TO: Mercedes-Benz Dealer Principals, General Managers, Sales Managers, Service Managers, Parts Managers	FROM: Gregory Gunther, Department Manager, Vehicle Compliance and Analysis, Engineering Services
RE: Recall Campaign 2018050003 Launch Notification Replace Driver Airbag Module MY18 190 253 (AMG GT-Class, GLC-Class)	DATE: May 11, 2018

RECALL CAMPAIGN LAUNCH NOTIFICATION

Campaign No. 2018050003, May 2018

SUBJECT: **Models 190 and 253 Model Year 2018**
Replace driver's airbag

Figure 1

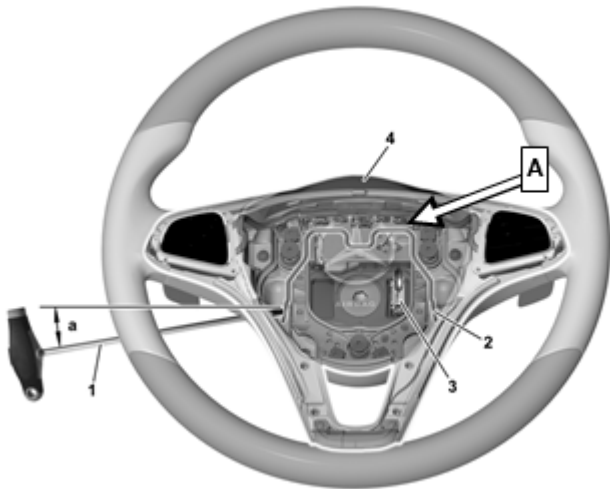
1. Disconnect ground line from on-board electrical system battery.
2. Replace driver's airbag (**A, figure 1**) on the steering wheel.
 - i** Basic data model 190 **AR91.60-P-0660EL**.
 - i** Basic data model 253 **AR91.60-P-0660LW**.
 - i** Contrary to the WIS work instructions, it is **not** necessary to check the supplemental restraint system using XENTRY/DAS following driver's airbag replacement.

3. Connect ground line.
4. Turn transmitter key in electronic ignition lock to **position 1** **or** actuate start button once without contacting the brake pedal (**ignition position 1**) and check whether airbag indicator lamp in the instrument cluster goes out permanently after a few seconds.
 - i** No farther SRS check is required.
